SERVICE BULLETIN

Model: PM4001/PM4001F

REF.NBR: MZ06-027

Improvement of Reliability

C901, C902, C903

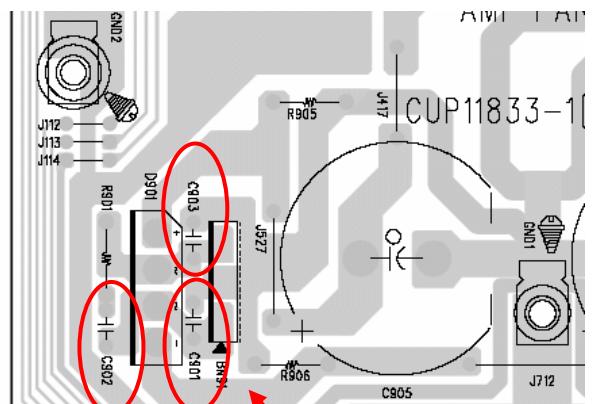
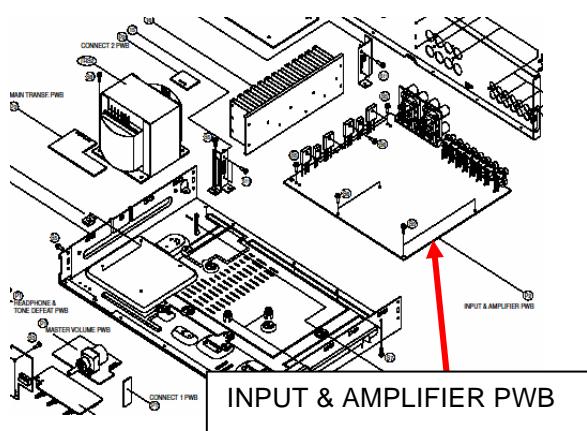
Under conditions of over voltage etc., the capacitors C901, C902 or C903 may be shorted and the thermal fuse of the power transformer will be blown.

POS.NO. C901, C902, C903 (CER CAP. 0.1uF 50V ZF) are changed (FILM CAP 0.1uF 100V) on the INPUT & AMPLIFIER PWB.
